ATTACHMENT G

### SUBJECT: RE-ZONING OF 931 MCCLURE STREET, VICTORIA BC

# SUBJECT: RE-ZONING OF 931 MCCLURE STREET VICTORIA, BC

Figure 3

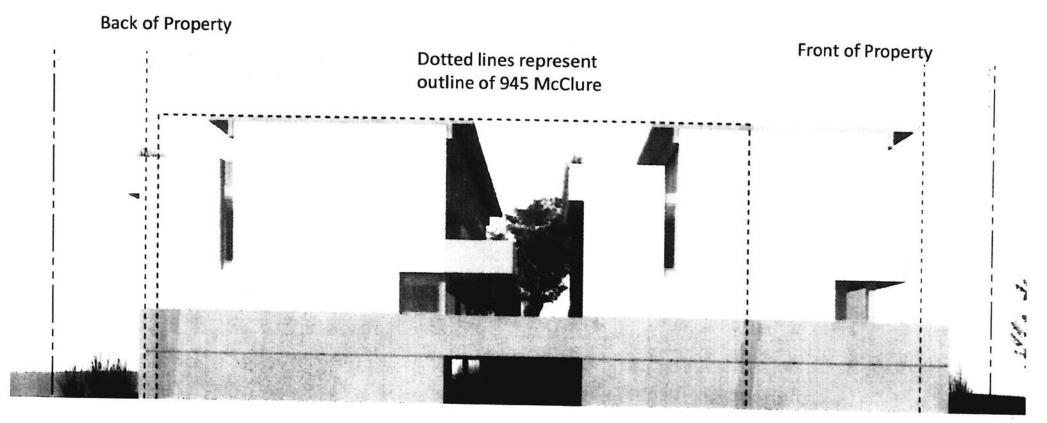
The proposed structure would extend to the very edge of the property line on both sides. On each side, it would present a blank wall, four stories in height, tight against the property line, and extending beyond the facing walls of the buildings on both east and west sides of it.

Our building at 945 McClure Street was not designed to face a blank wall on either side, especially one right at the property line. Our west facing wall contains 8 units on 4 levels. Each unit has 7 windows in this wall, located in 3 separate rooms. All 56 windows would face a massive blank wall that is only feet away.

Sunlight would be eliminated, and daylight significantly reduced, in all 8 units on the west side of our building, by the height, extent and placement of the east wall of the proposed building.

Figure 4

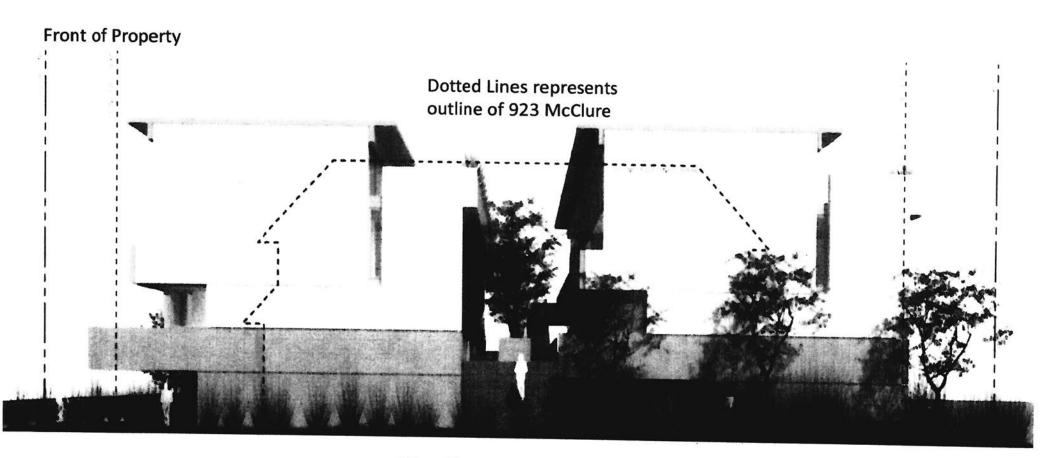
The townhouses at 923 McClure were similarly not designed to face a blank wall right on the property line. They have entry doors, a porch, and windows on two levels in their east facing wall.

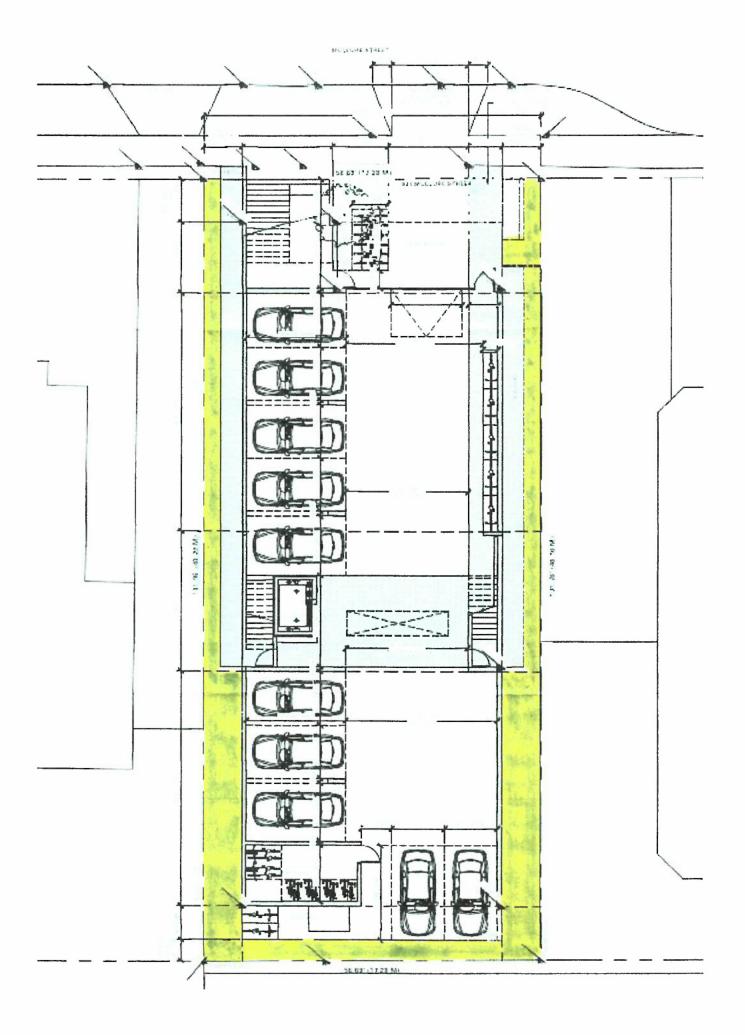
The mass of the proposed building has increased from 4 storeys in the original proposal (2018-10-31) to 4 storeys at the front and 6 storeys at the back in the latest revision (2021-01-29). Significantly, the latest plan will create a side yard setback of only 2.00 metres ( $6'-6 \frac{3}{2}''$ ) to the east and west, only 2.25 metres ( $7'-4 \frac{1}{2}''$ ) in the front, and only 1.12 metres (3'-8'') in the back. Walkways extending halfway along the building on the east and west sides reduce the unpaved setback in these areas to only 3 feet.

The area shaded green in the attached drawing shows what little natural surface remains. Virtually the entire lot will be consumed by building and paving – a hardened surface impermeable to water.
